**RE: Addendum to the Contract Documents for the West High Service Pump Station  
Bid No. ITB-4221**

**ADDENDUM NO. 3  
TO  
BID DOCUMENTS  
FOR  
WEST HIGH SERVICE PUMP STATION  
FOR THE  
CITY OF ANN ARBOR, MICHIGAN**

WEST HIGH SERVICE PUMP STATION  
 Ann Arbor, Michigan

Project No.	Scale	
2075117301	AS NOTED	
Drawing No.	Sheet	Revision

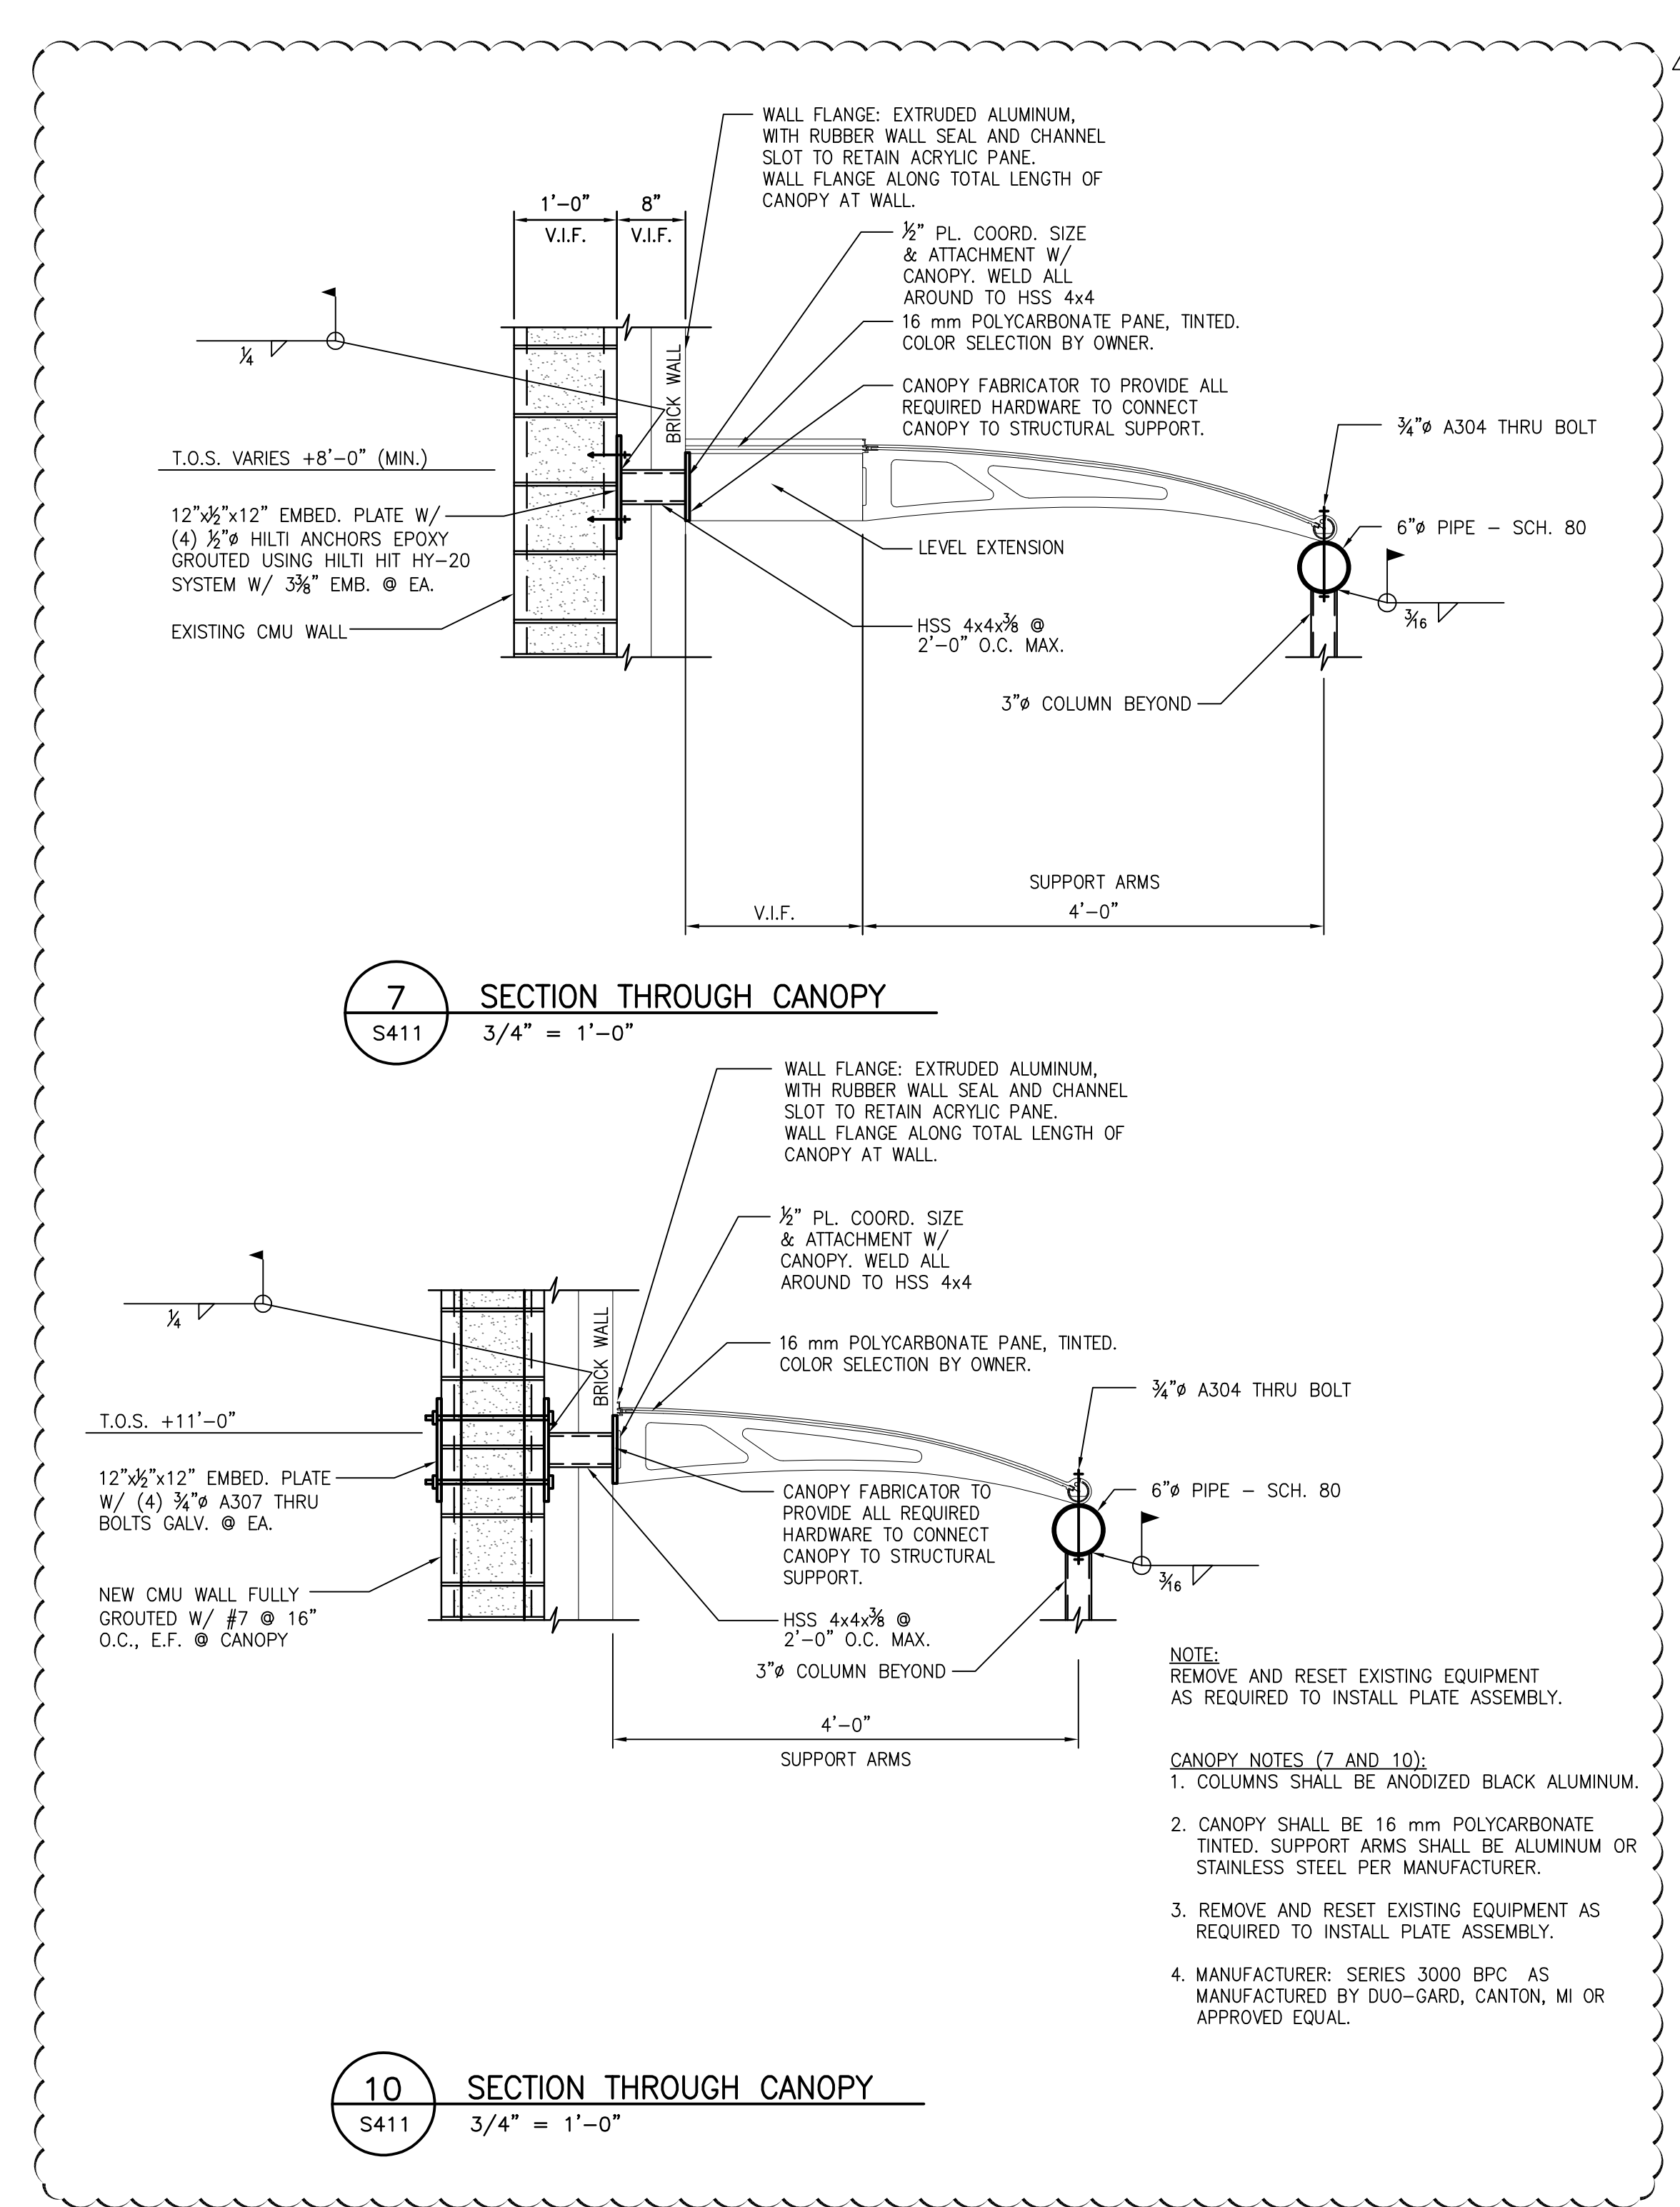
**Revise** Drawing S-411 to add canopy detail notes.

MECHANICAL - HVAC  
 BOILER SYSTEM UPGRADE  
 NEW BOILER ROOM - PLAN

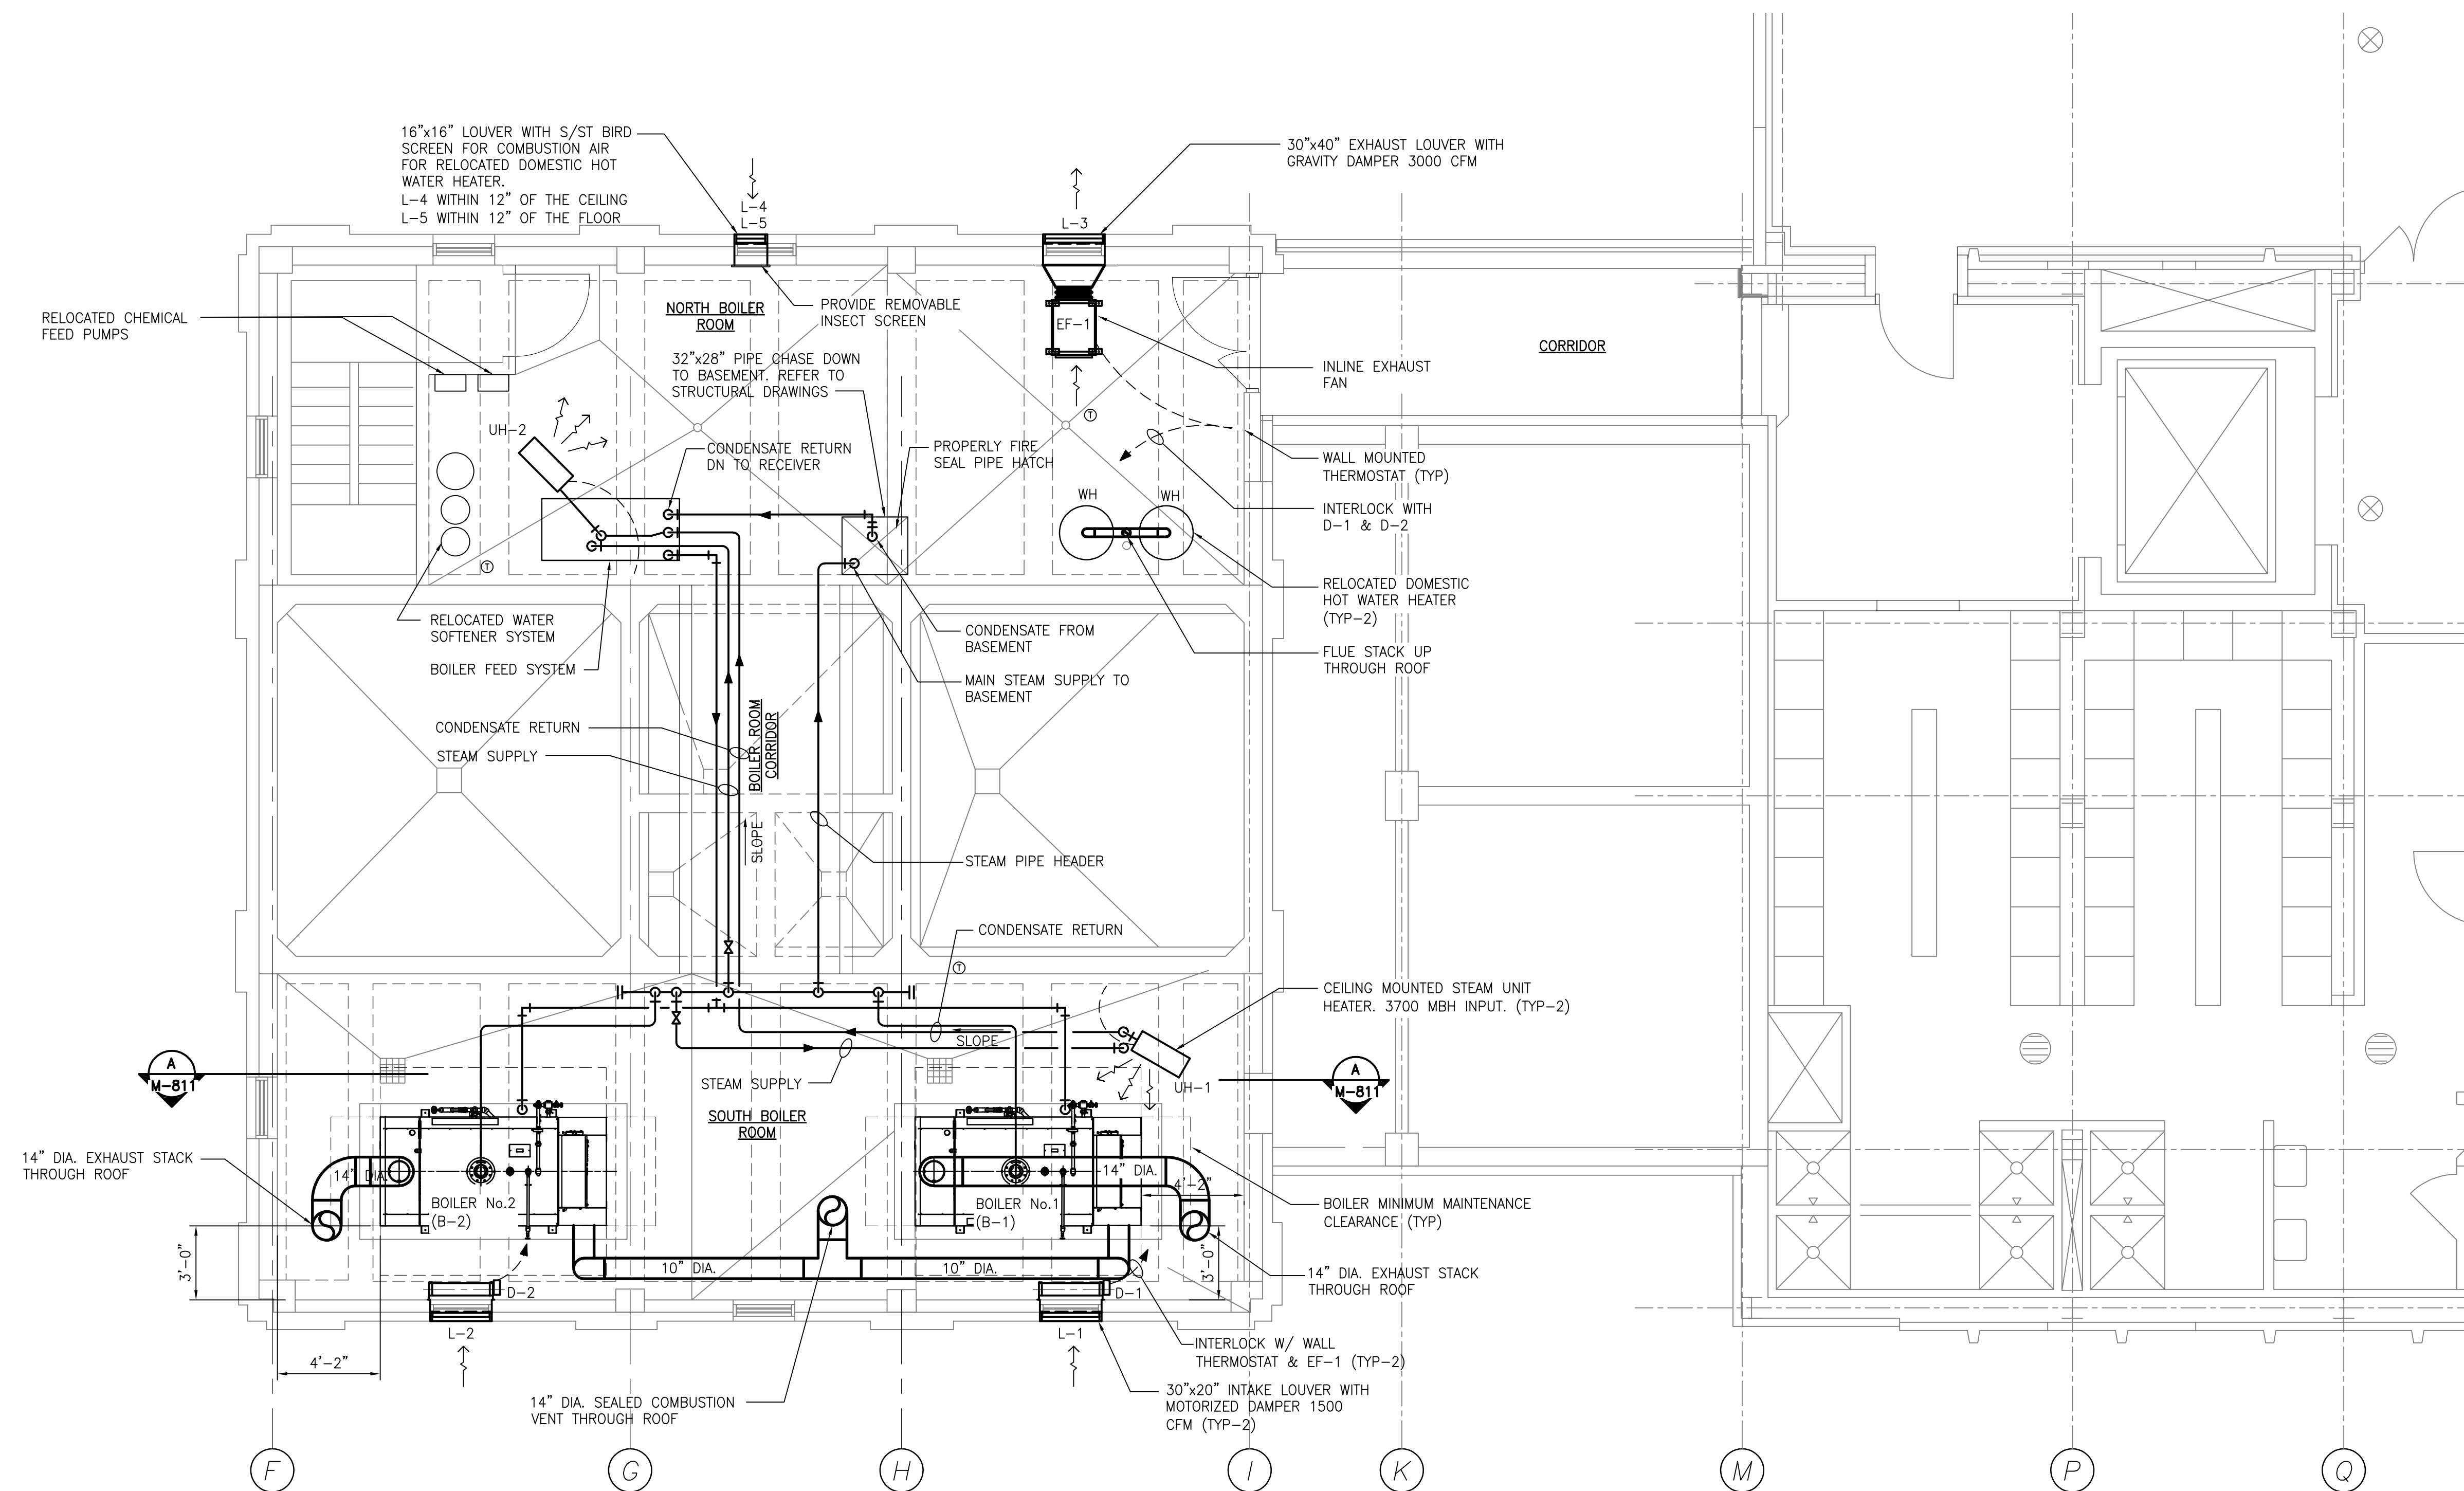
**Revise** Drawing M-810 to add exhaust stack notes.

**NOTE:**  
 THE (2) 14" DIA. EXHAUST STACKS THROUGH THE ROOF SHALL BE LOCATED 10'-0" FROM THE FACE OF THE MASONRY PENTHOUSE ON THE ROOF TOP.

**CONTRACTOR SHALL:**

1. REMOVE EXISTING ROOF DRAINS CAST INTO THE EXISTING CONCRETE ROOF.
2. CORE NEW OPENINGS FOR THE STACKS (2).
3. CORE NEW OPENINGS FOR THE ROOF DRAINS TO BE RELOCATED (2).
4. SET NEW PANS, DRAINS, DOMES AND RE-PIPE AND CONNECT TO EXISTING ROOF DRAIN LINES.
5. INSULATE ROOF DRAINS, PIPING AND PANS PER SECTION 15250.
6. REPAIR ROOFING AT ALL NEW PENETRATIONS.
